GULF STATES UTILITIES COMPANY

River Bend Station-Unit 1
Docket No. 50-458

As requested by your Staff, enclosed are revisions to the Gulf States Utilities River Bend Station Environmental Qualification Document, Appendix B.1, System Component Evaluation Work (SCEW) sheet SRN 247491-3. These revisions support the justification for interim operation for two air operated valves (1DFR*A0V144 and 145) in the suppression pool pump-back system previously provided in GSU's August 13, 1985 letter.

SRN 247491-3
REV 2-3
SHEET NO. 2
DATE 8/11/85-8/14/85

SRN 247491-3

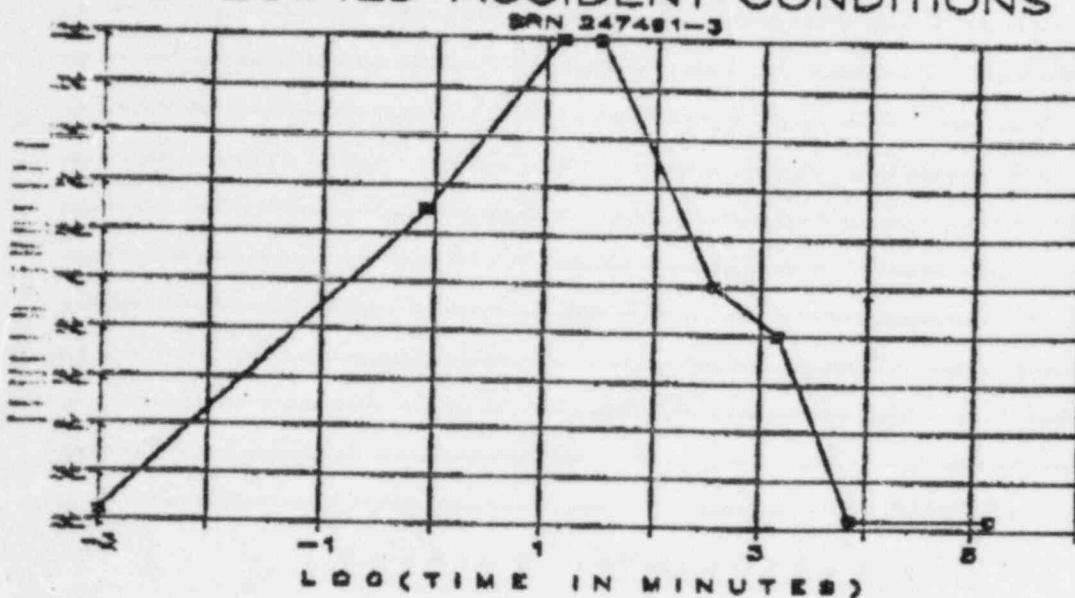
1. For complete environmental conditions, see ^{documents}~~conditions~~ referenced. X
2. For qualified life, see Reference 4. In the qualified life calculation, the temperature rise ^{coil}~~by the actuated coil~~ is considered. X
3. Operability time extended from 30 to 100 days plus margin by the Arrhenius calculation. See Reference 4.
4. The qualified life of this component can be extended to 40 years by periodic maintenance or replacement. See References 2 and 4.
5. Safety Functions - Control steam pressure in heat exchanger; control heat exchange water level; ~~and~~ standby service water isolation valve for penetration valve leakage; control compressor; and isolate auxiliary building floor drains. X
